A G E N D A

Architectural Review Board

May 24, 2022 – 5:30 p.m.

511 Martha Street, Cottage Hill, 5/6/22

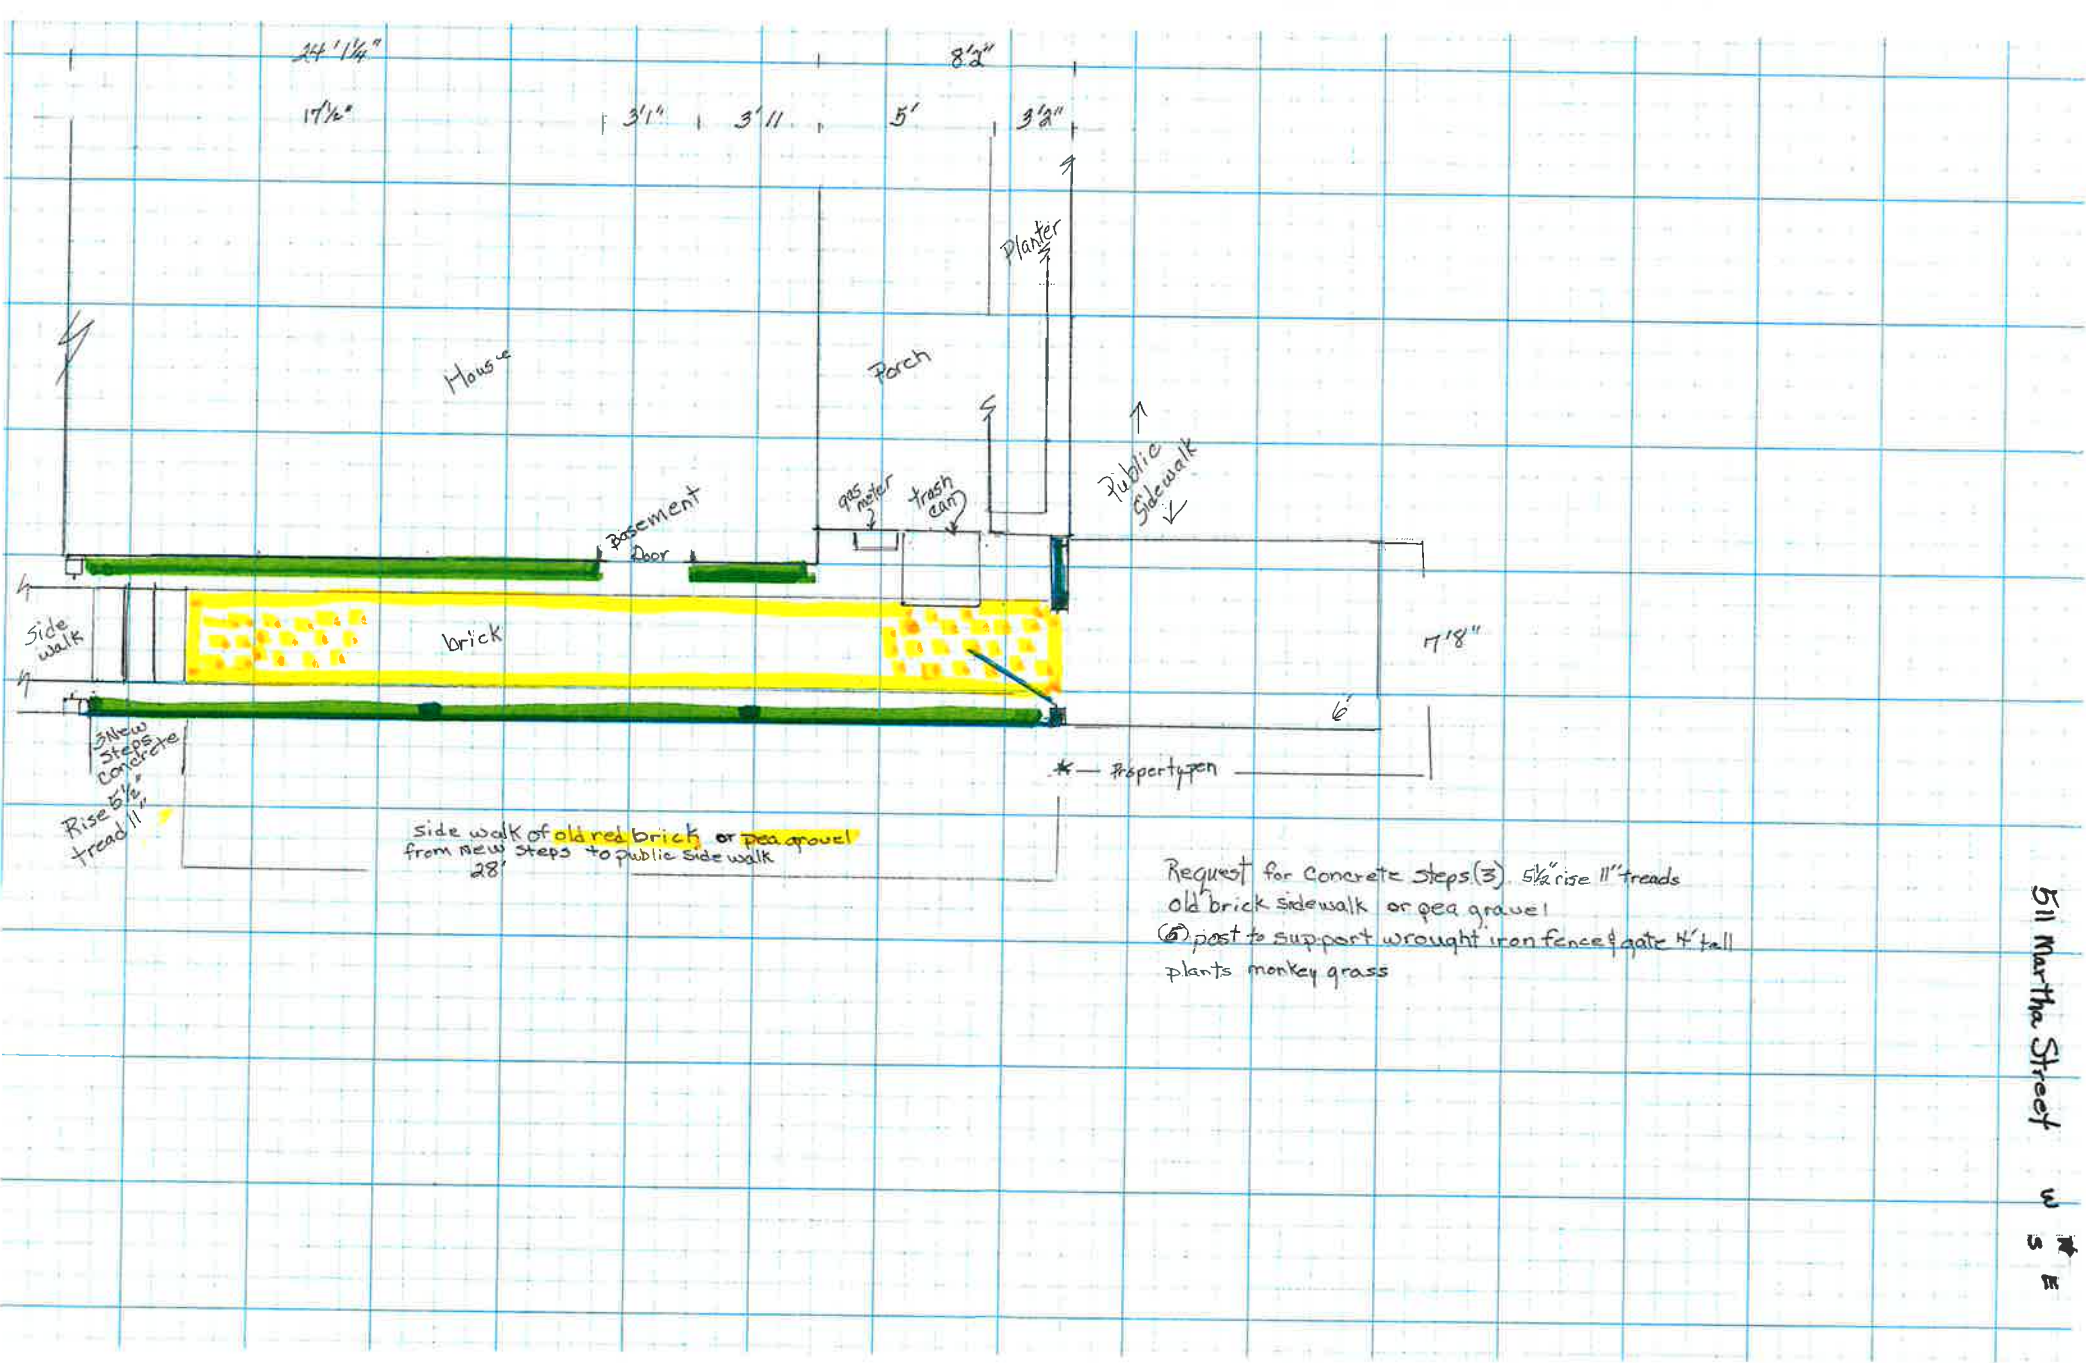
- Of all our residential historic districts, Cottage Hill is the best/natural candidate for introducing pedestrian friendly front yard fences and gates. The proposed design is unobtrusive. No objection.

608 North Court Street, Individual, 5/6/22

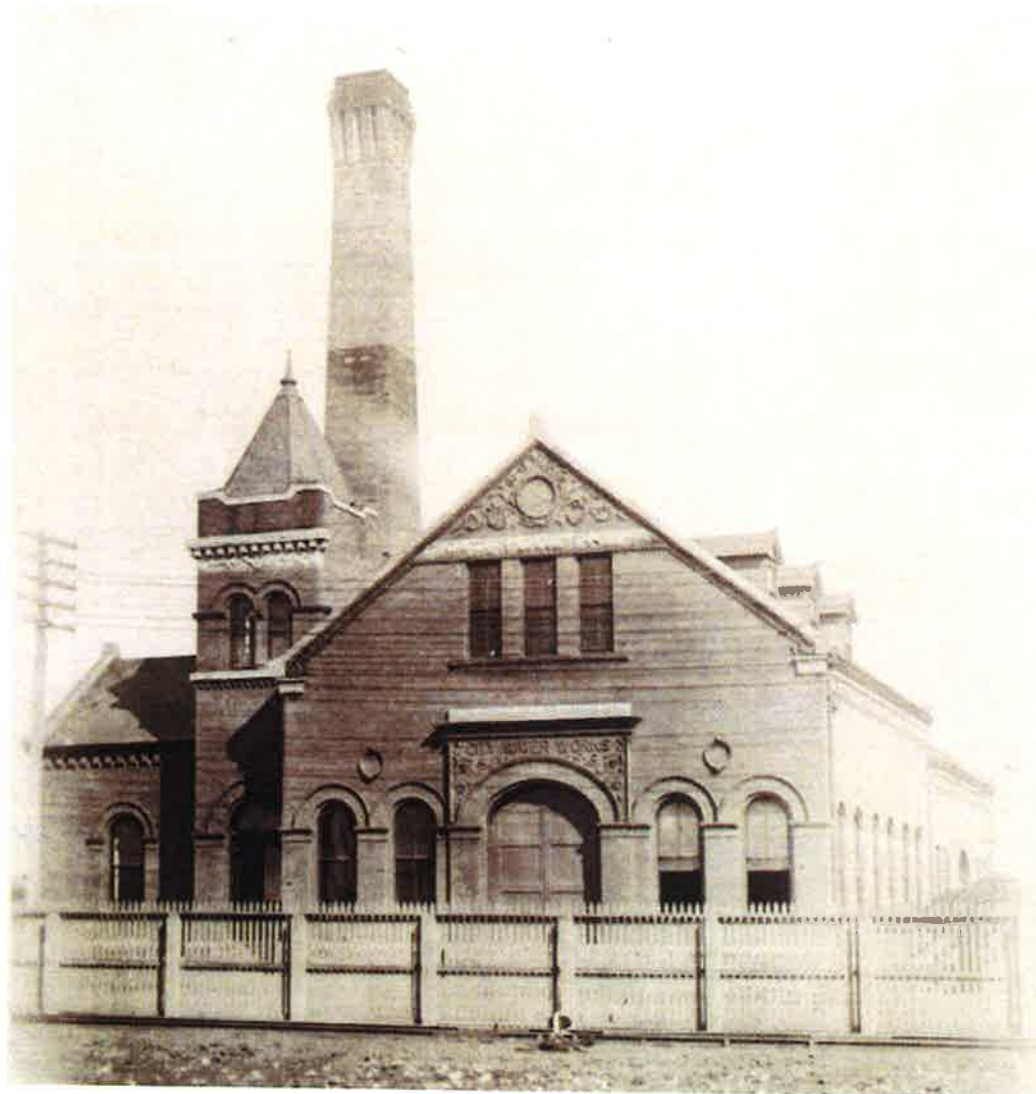
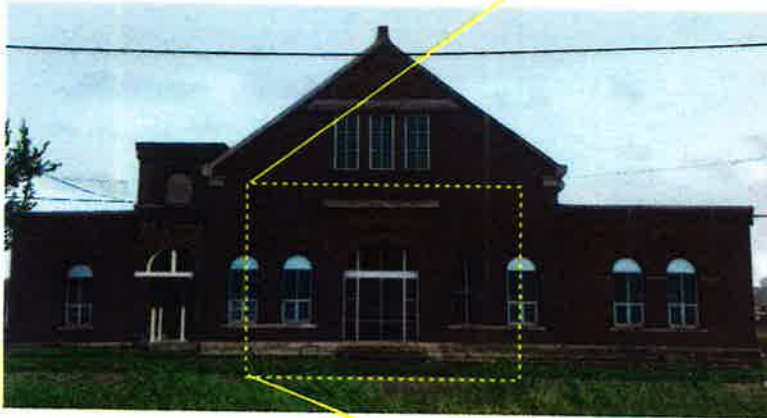
- Since the existing lettering is not being touched, this would be an easily reversible change.

538 E. Fairview Avenue, Cloverdale Idlewild, 5/6/22

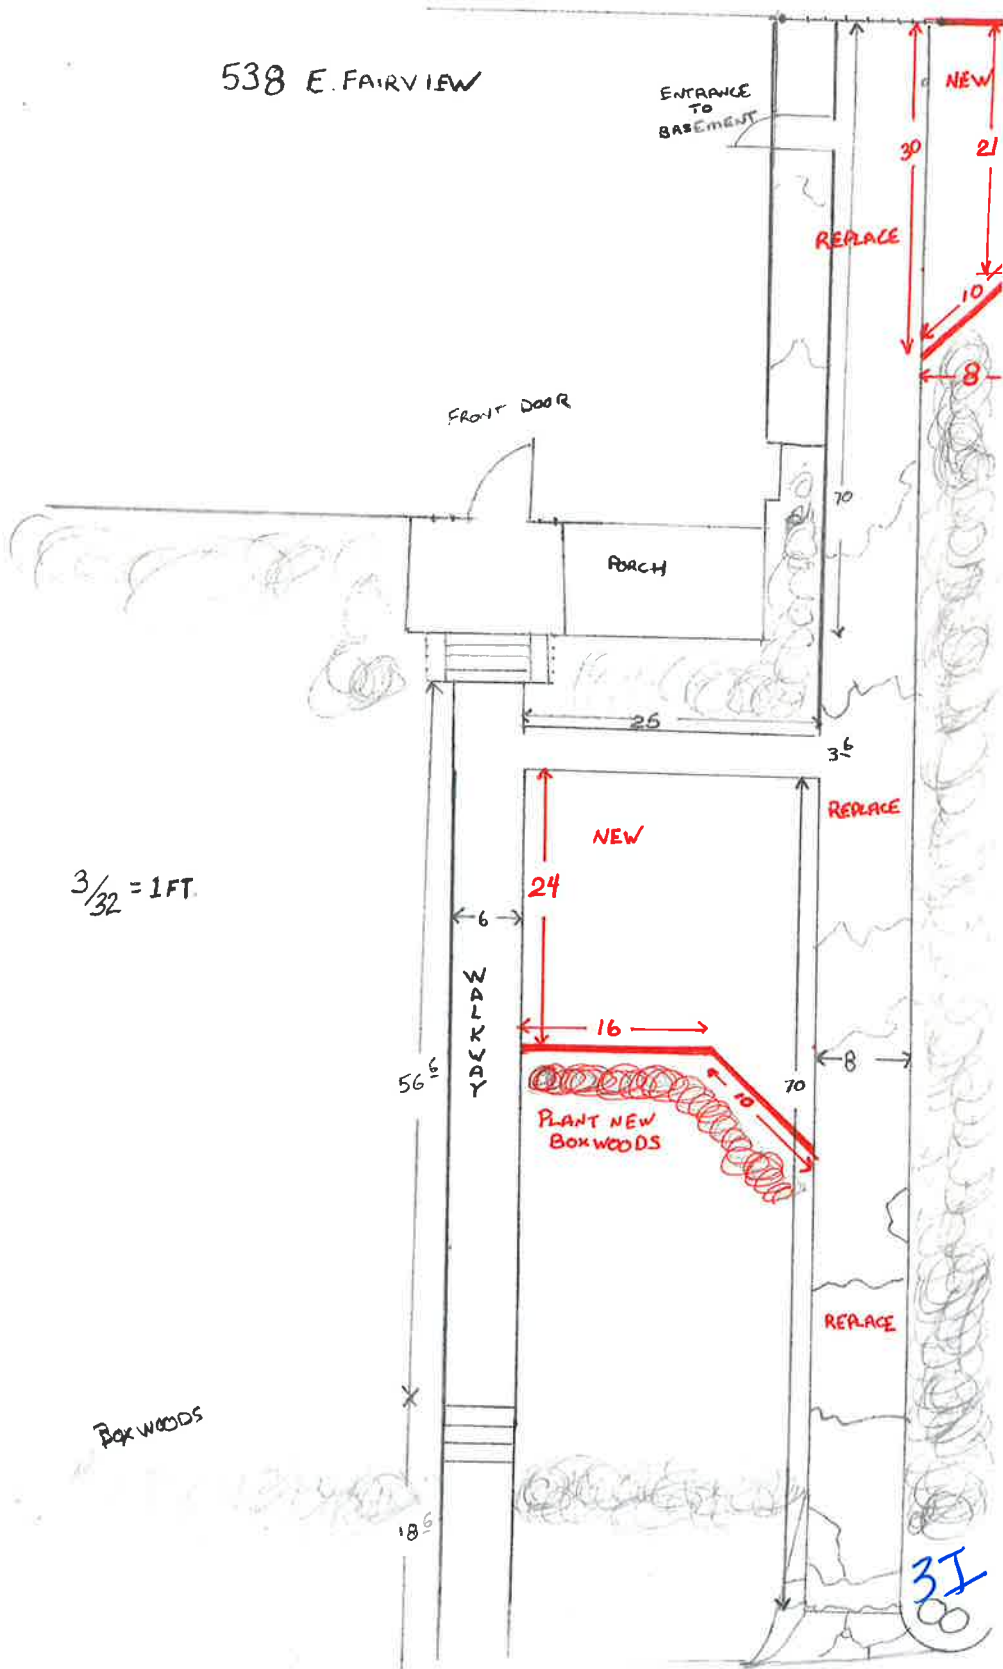
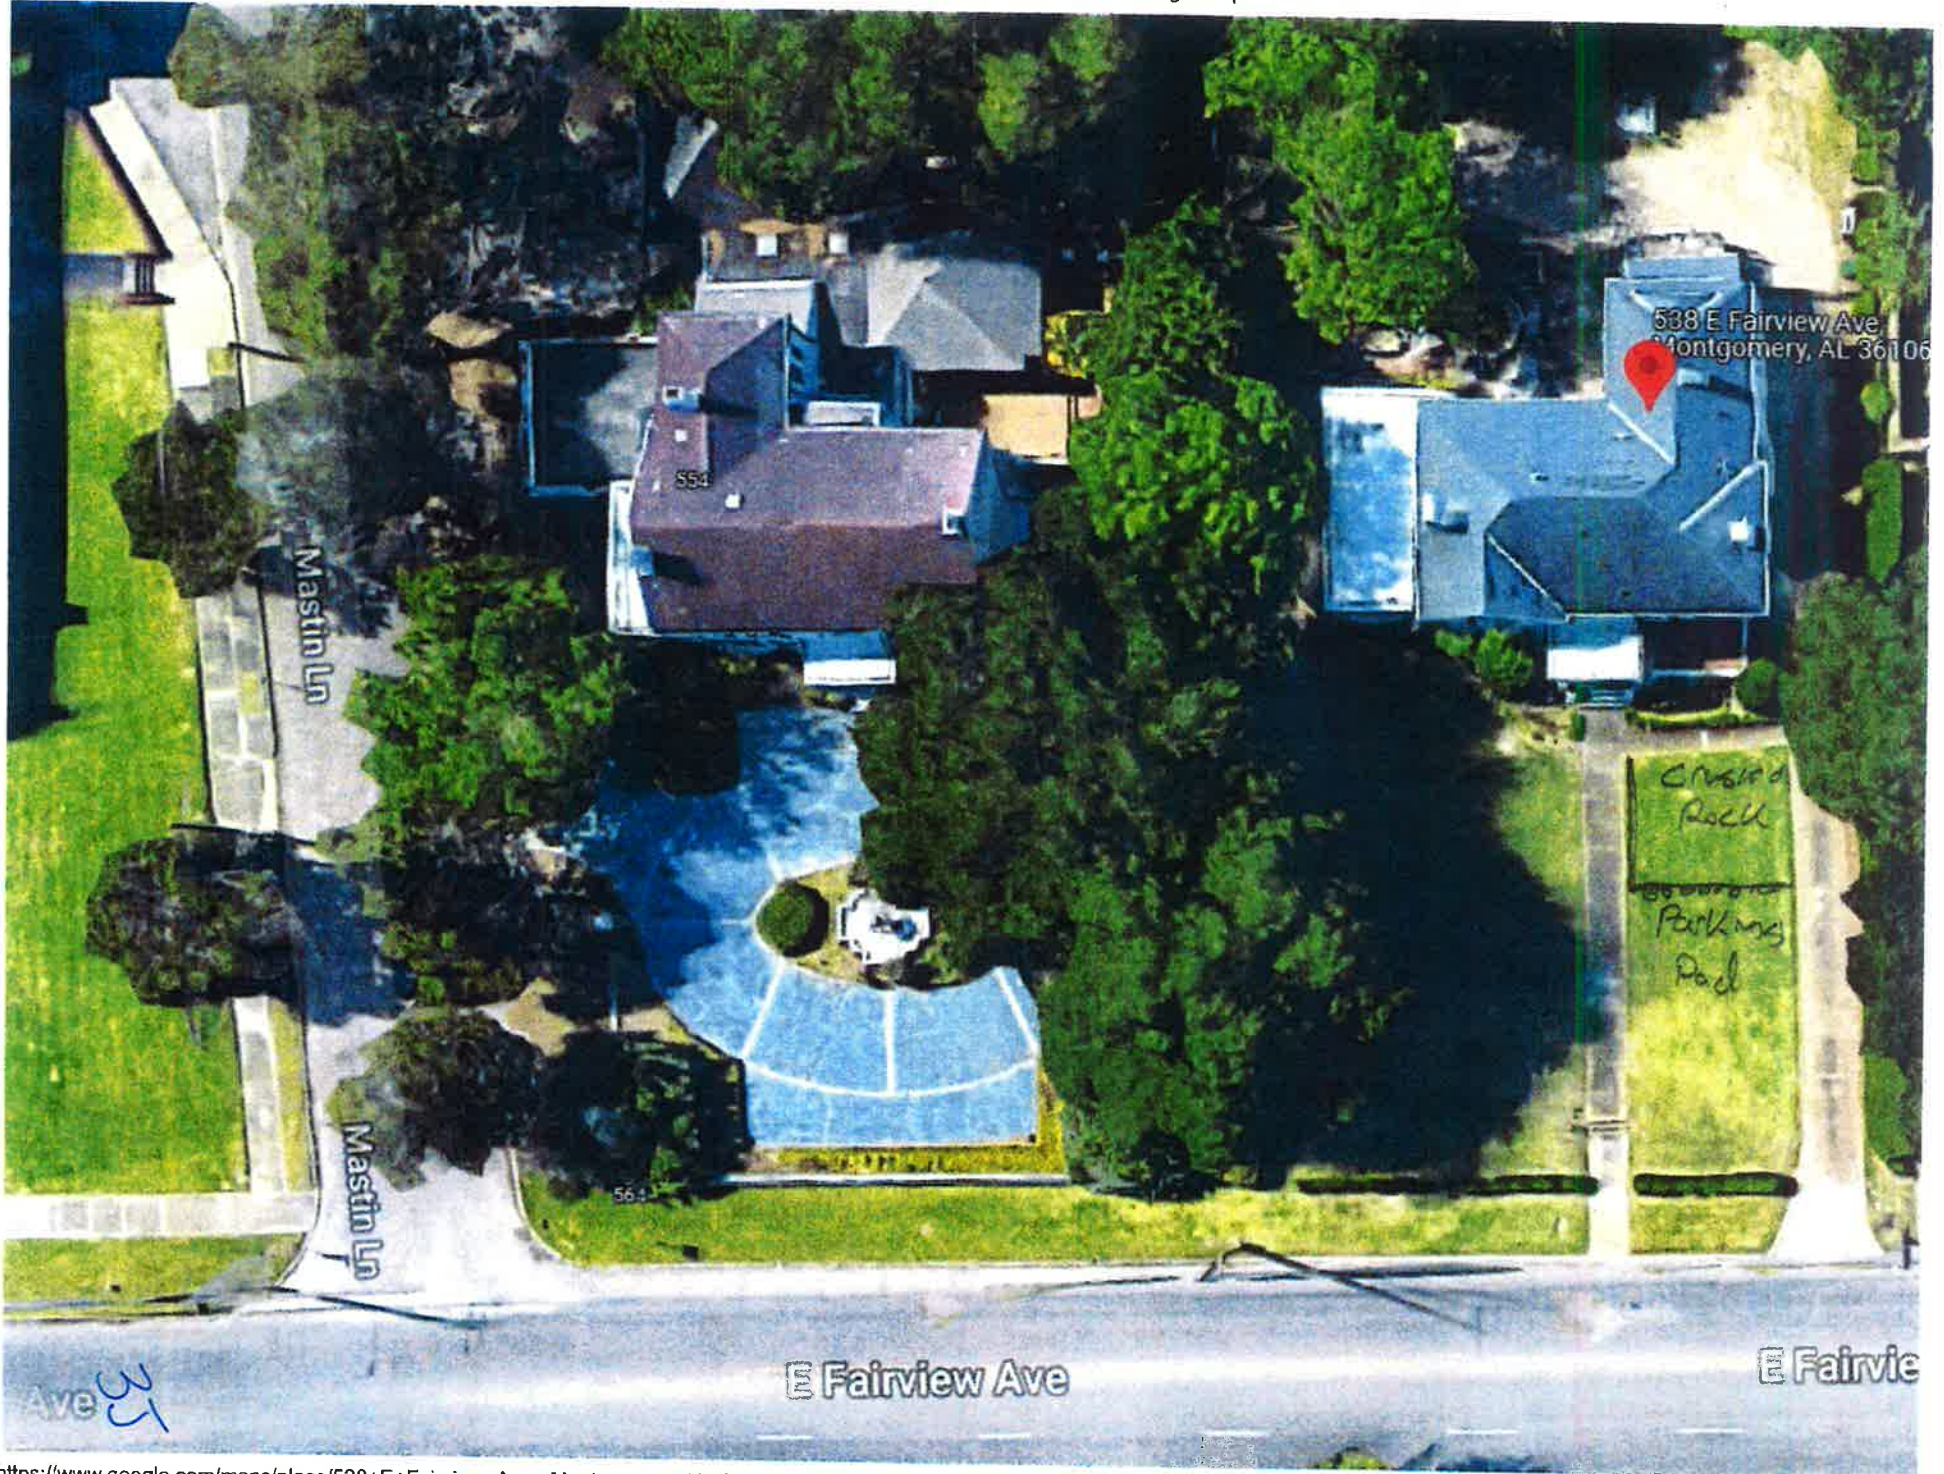
- What was discussed with Mr. Muraki was that the parking pad was too large, 24'x25' exceeds what has usually been considered, which is 20'x20'. Shortening the 25' length to 20' would have created a green, visual buffer between the pedestrian walkway to the front door and the parking area, which has been required when parking pads or driveway widenings have been approved to avoid visual and physical encroachment of vehicles on a walkway. He was advised that if the Board was to approve front yard parking, if it was deemed necessary, there would have to be more visual buffers than what is proposed. There is no site plan that shows this configuration.

- The widened parking area near the house would require the removal of a mature hedge, and any barrier between this property and 528 E. Fairview. A survey should be completed to determine whose hedge this is, ARB approval of a project would not grant an individual to do work on property that is not theirs without that owner's consent.

- The number and spacing of boxwood has not been specified. Any screening should follow the city landscape ordinance guidelines, plants should be 18" tall at installation, planted 3' on center.

- The expanse of gravel in the rear yard negates any need for front yard parking. One of the nearby examples submitted by the petitioner was the ARB approved parking for 700 E. Fairview (the house next door predates designation). The houses are on two very different lots in terms of topography and size, so that the parking at 700 E. Fairview does not encroach on the visual aspects of the house and its architecture.

- Based on the work that has been done, both in the front and rear yard, and the lack of additional or revised submissions, it is the recommendation of staff that the front parking area be denied as it was submitted as it detracts from the character of the house and the district, and is unnecessary with the availability of parking in the rear yard, and the front lawn be re-sodded (gravel and pine straw); and that the rear gravel be left in place as installed to insure the long term health of the live oak tree.
